CAMPUS AREA NEIGHBORHOOD ASSOCIATION

Lake Street Garage Steering Committee Report

November 21st, 2022

Alternate Layout

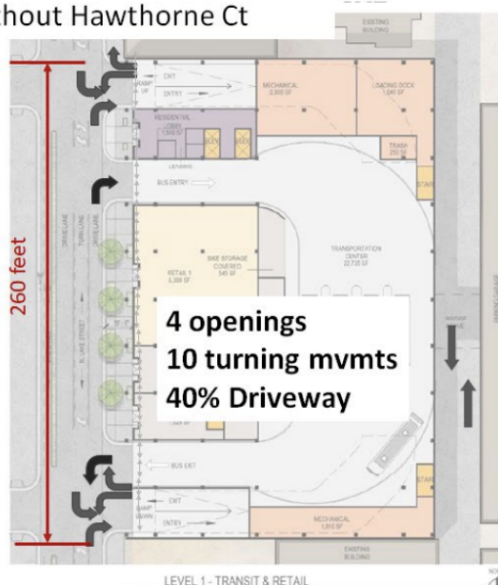
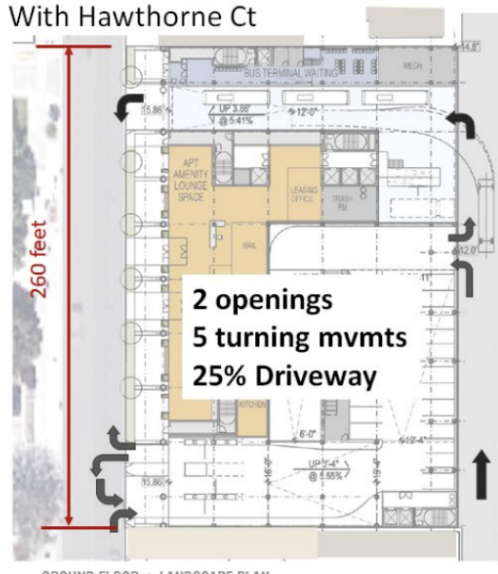
The three spots for buses seem inadequate and are shortchanging the intercity bus station potential. The bus terminal ought to have five bays like the old bus terminal and there needs to be a better plan for staging. They are trying to do too much at once and seem to be modeled after La Crosse without consideration of the unique challenges of this area. The Bus terminal is different and you can drive straight through it. This design

seems too complex at the moment. The proposal does not seem to completely address everything. The entrances for residential parking are on the same side as the Van Galder Bus entrance. This mix of traffic seems problematic with bus schedules and the residential experience. If there is a queue that wraps around the corner, this will affect the BRT lane and Metro Bus lane. There is also a need for more entrances and exits to accommodate queues during special events.

The alternative layout provided by the City of Madison Transportation Department

- Moving the entrances to the bus terminal and parking to Lake Street
- Creating a Transportation plan that considers all modes of transportation on the site
- Using this project to activate Hawthorne Court with public art, lighting, and cameras
- Make the bus terminal part of a covered part of Lake Street.
- We need a complete Traffic/Environmental Study that considers the impact on local businesses, existing apartments, and all current modes of traffic circulating through this site.
